Field Notice

HysteroLux™ Fluid Management System Control Unit – REF 72205000

WOM reference no.: 2021-0002

Figure 1 Pump Control Unit display showing the calculated deficit (Deficit display) and inflow volume count (Total Inflow volume display). The latter will freeze, once 32,450 ml has been reached.

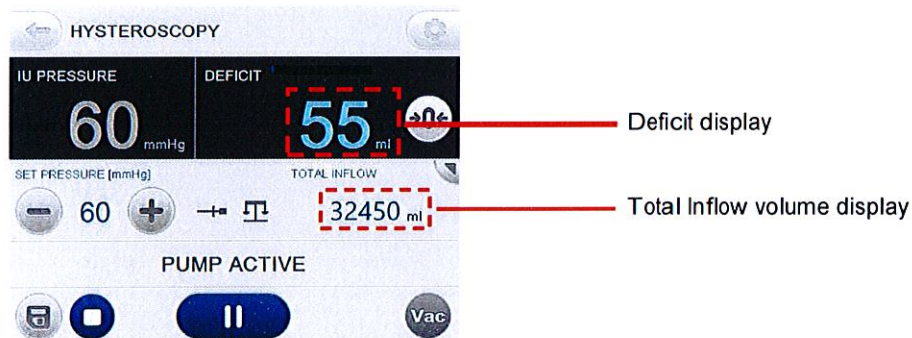
This field notification is being issued following reports from customers from the USA that the display of inflow volume on the HysteroLux™ Fluid Management System can reach its limit of 32,450 ml during long procedures. In these cases, the display does not indicate the actual inflow volume. In cases where an unusually high amount of fluid is used for distension of the patient's uterus, the calculation of the inflow and outflow volumes reaches its limit and the Control Unit display will freeze at the maximum value.

Our investigation has identified a software anomaly as the cause for this display freeze. The reason for this is that at 32,450 ml an internal software calculation threshold is being reached. As the outflow measurement will continue, the result is that the deficit accumulated up to this point will start counting backwards until 0 ml is reached.

W.O.M. WORLD OF MEDICINE GmbH has developed a software version, which, when an inflow volume of 28.000 ml is reached, alerts the user that the limit is being approached and is designed to prepare the user for a manual determination of the deficit.

The new software version is implemented during the next preventive maintenance of your HysteroLux™ Fluid Management System Control Unit. If you wish to update the software of your device at an earlier date, please contact your sales representative of Medtronic Inc., who will assist in returning the unit and providing an exchange unit.
